Baseline Resource M1997058- AR and SR Inspection Report

MINERALS PROGRAM INSPECTION REPORT PHONE: (303) 866-3567

MINE NAME:		MINE/PROSPECTING ID#:	MINERAL:	COUNTY:
Baseline Resource		M-1997-058	Sand and gravel	Weld
INSPECTION TYPE:		WEATHER: Clear	INSP. DATE:	INSP. TIME:
Surety Release Inspection			August 21, 2025	08:00am
OPERATOR:		OPERATOR REPRESENTATIVE:	TYPE OF OPERATION:	
Hall-Irwin Aggregates, LLC		Damon Zuetell	112c - Construction Regular Operation	
REASON FOR INSPECTION:		BOND CALCULATION TYPE:	BOND AMOUNT:	
Surety Release Requested		Complete	\$75,380.00	
DATE OF COMPLAINT:		POST INSP. CONTACTS:	JOINT INSP. AGENCY:	
NA		None	None	
INSPECTOR(S):	INSPECTOR'S SIGNATURE:		SIGNATURE DATE:	
Chris Girardi	Ch	ur Diradi	October 10, 2025

Photo 9: View of the recreation area and seeded area along the eastern pond shoreline of Area A, facing north.

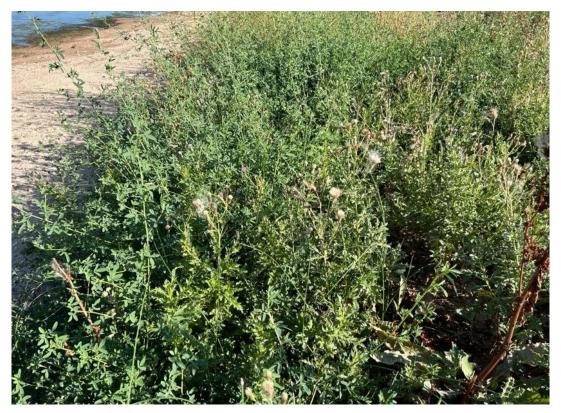
The 27.90-acre area designated as Area A that also has been requested for release contains a lake with flat shorelines (see Photo 8-11). This area also contains a permanent access road on the southern side. PVP pipes marked the eastern permit boundary in this area. Much of the shoreline is dominated by Narrowleaf willow and other wetland species. 1.8 acres are reserved as a recreation as area for RVs and boats (see Photo 9). The Division notes that the reseeding in this area is moderately established in some patches but still will require additional seeding before release for some areas (see Photos 5-8). Seeding conducted on adjacent to the

north and south of the access road yielded little to no establishment of the reclamation seed mix (see Photos 6-8). North of the recreation area, the lake shoreline exhibited good coverage of grasses (see Photos 11-12) and will not require additional seeding events.
